PLANNING BOARD MEETING

Trim Way Def. Subdivision- Response to Peer Review Comments

358 & 360 North Street Randolph, MA 02368

Trim Way

Lotting Plan with Markups Enclosures:

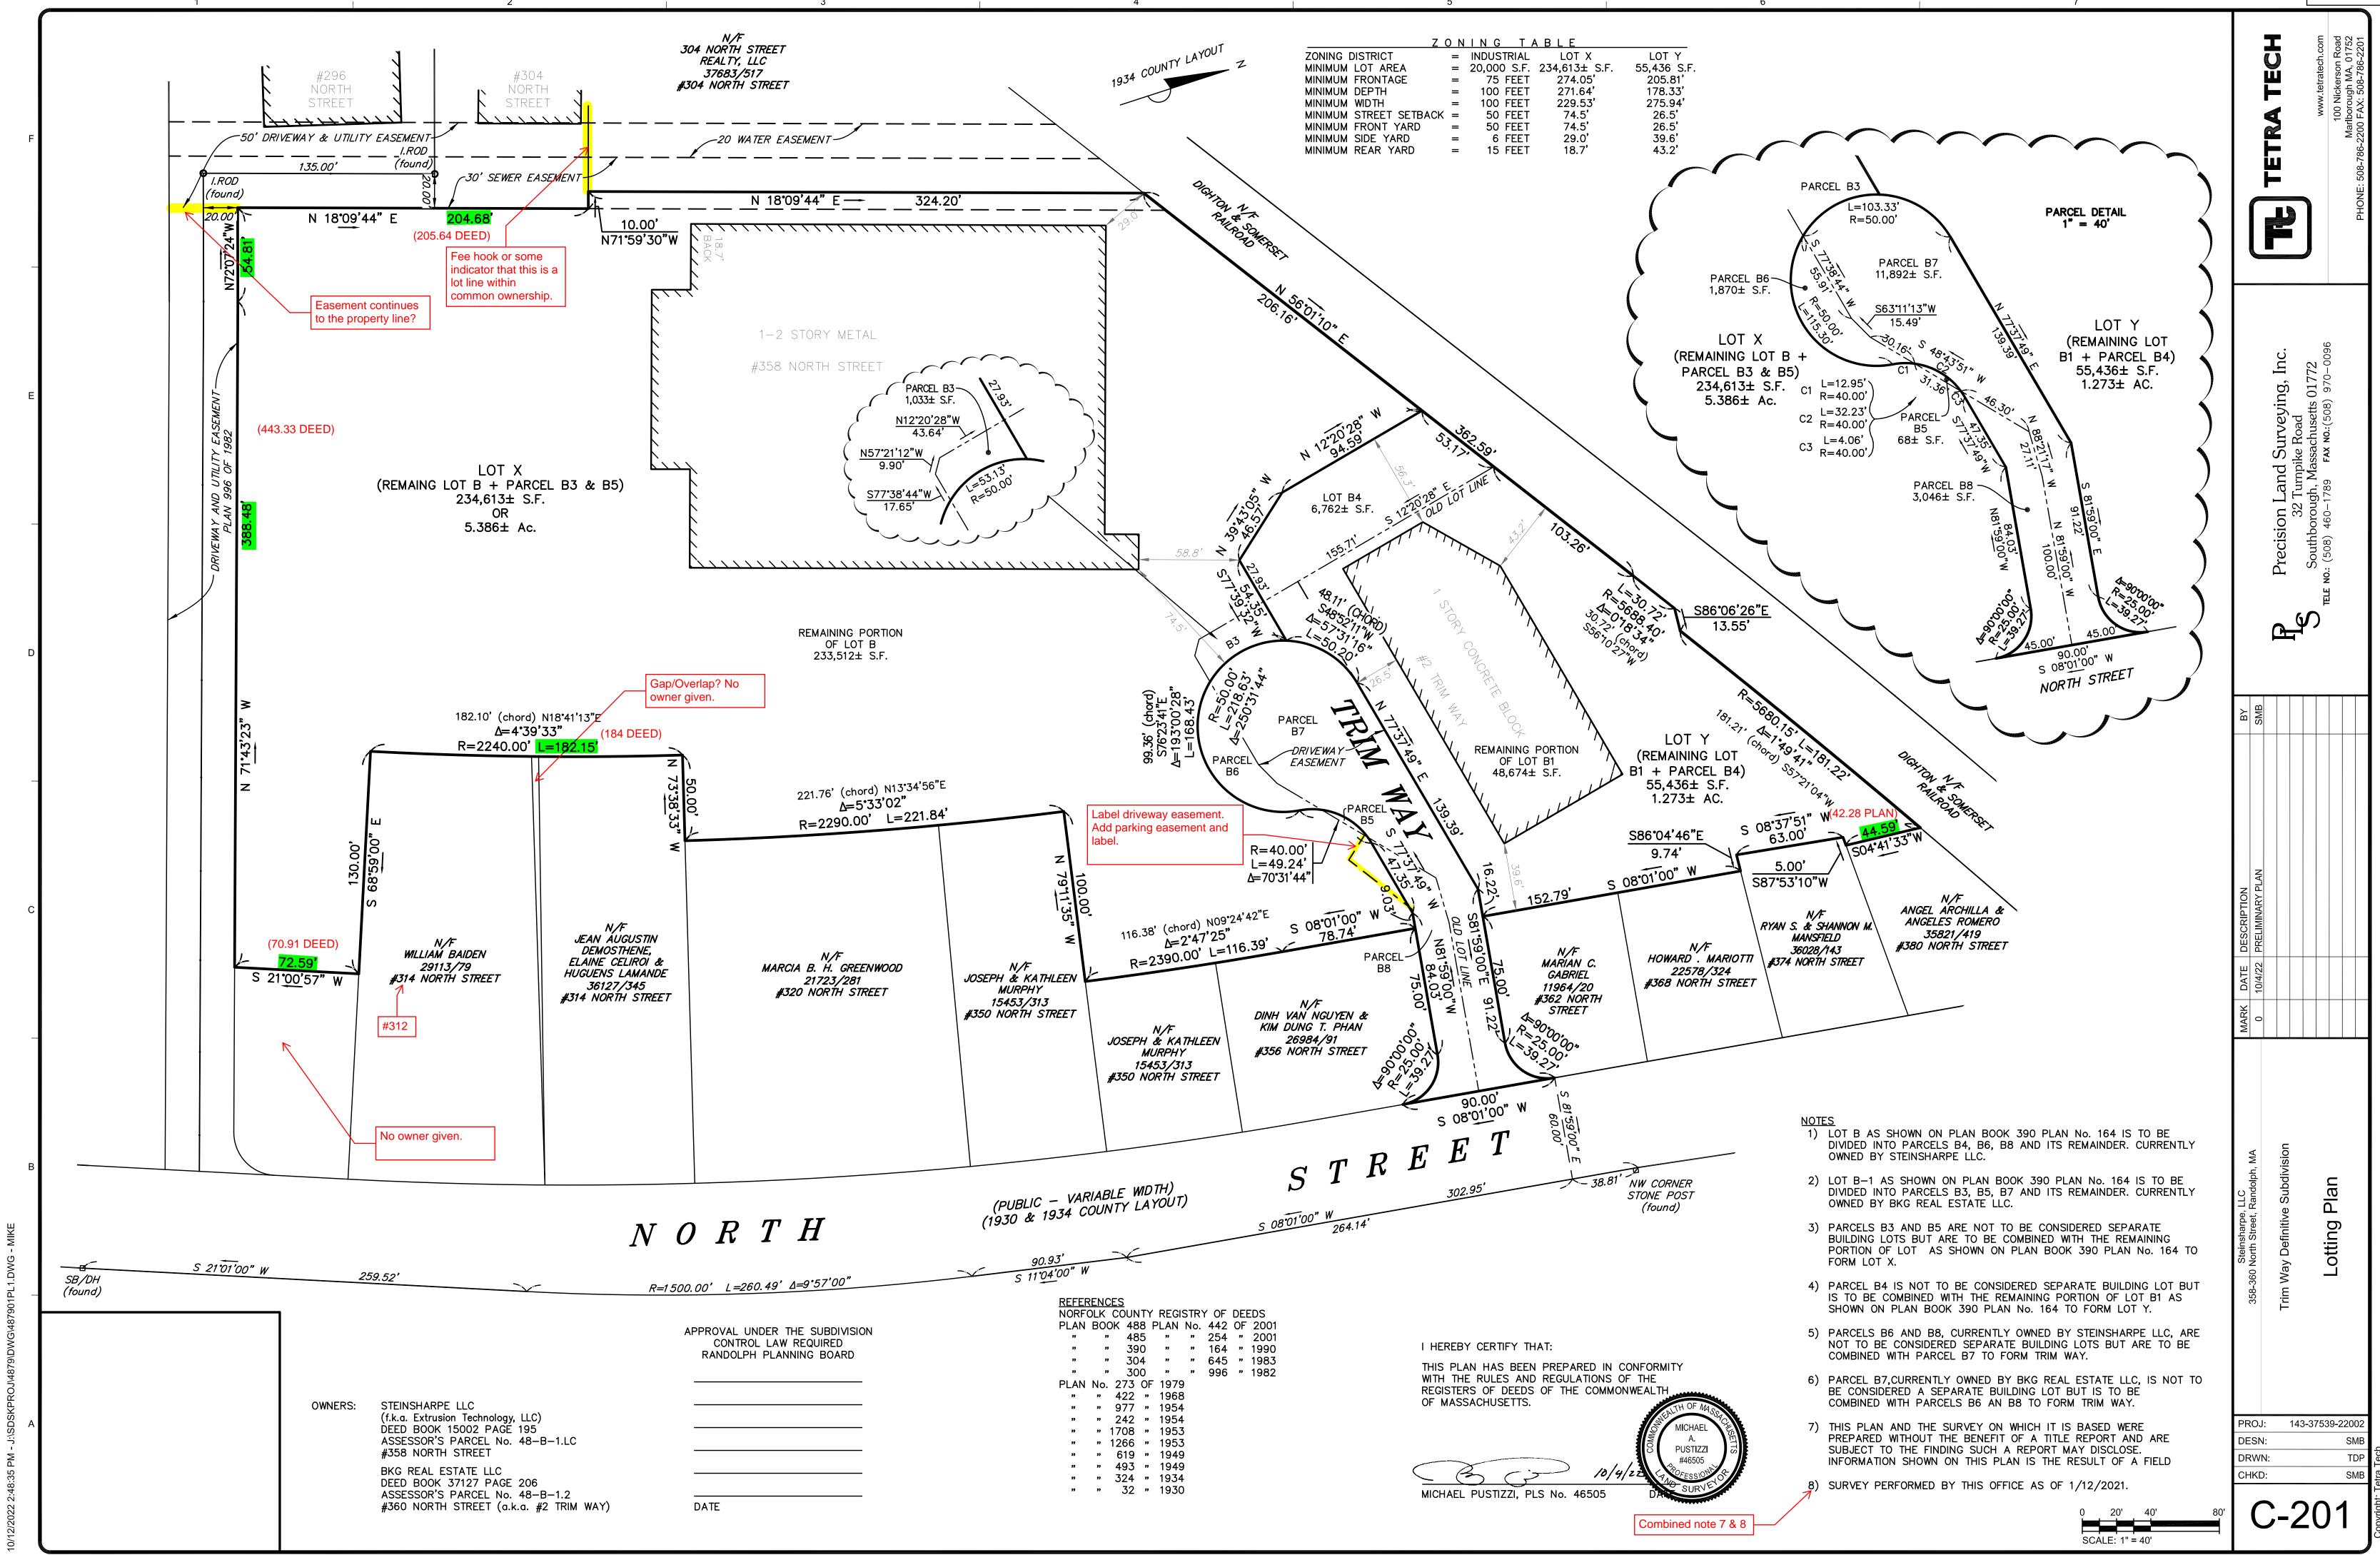
- Several of the distances shown on the Lotting Plan differ from the record deed or plan for the parcel. See green highlighted distances on the attached plan.

- A portion of the existing driveway easement is shown on the south side of Trim Way, but it is not labeled as such. There is also a parking easement adjacent to the driveway easement that is not shown at all. If these easements have not been extinguished, they should be shown on this plan.

- There appears to be two (2) property lines between #312 and #314 North Street. It is unclear if this is indicating a gap or overlap in the lots, but there is no indication in the record documents that this should be the case.

- The Owner and Title reference are not given for #310 North Street.
- The 50-foot easement line is not fully plotted.
- The lot for #304 North Street is comprised of two (2) lots under common ownership. The way the Lotting Plan shows the internal lot line makes it appear as though they are separate lots. A fee hook or some notation that the line is an internal lot line would clarify this.
